9.4 Air Conditioning, Heating, Cooling and Ventilating Systems

The information in this section of the reference ABWR DCD, including all subsections, tables, and figures is incorporated by reference with the following departures and supplements.

Figure 9.4-2c Turbine Building Electrical Equipment Areas (EEA) HVAC System Diagram

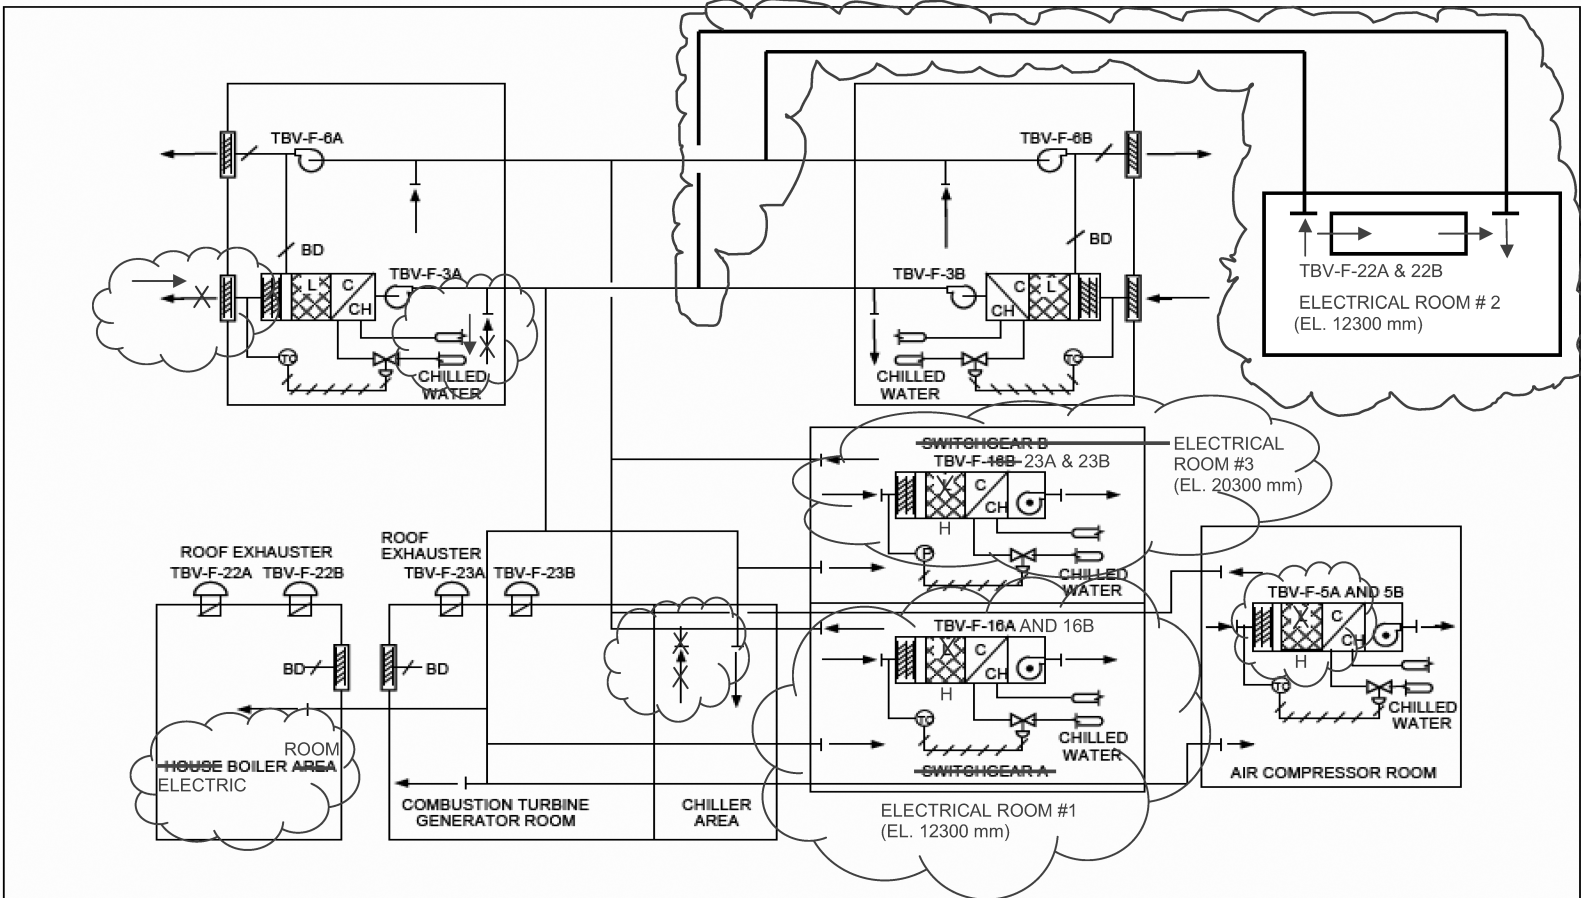
STD DEP 9.4-4 (Tables 9.4-3, 9.4-5, 9.4-5a, 9.4-5b, 9.4-5c, and 9.4-5d), (Figures 9.4-2a, 9.4-2b Sheet 2, and 9.4-2c)

The ~~E/B~~ EEA HVAC schematic diagram is shown on Figure 9.4-2c.

The Electrical ~~Building~~ Equipment area HVAC System is provided with two 100% capacity air supply fans and two 100% capacity exhaust fans.

The air supply fan draws outside air through louvers, control dampers, low efficiency filters, electrical heating coils, and chilled water coils, and discharges air directly into the ~~switchgear~~ electrical rooms, chiller, combustion turbine generator, ~~house~~ electric boiler room and air compressor rooms. Return air ~~Ductwork~~ ductwork ~~and bypass dampers are~~ is provided to allow recirculation of air from the ~~switchgear~~ electrical rooms and ~~chiller rooms~~ air compressor room.

The ~~E/B~~ EEA HVAC system maintains the Electrical ~~Building~~ Equipment Areas at a positive pressure with respect to atmosphere.
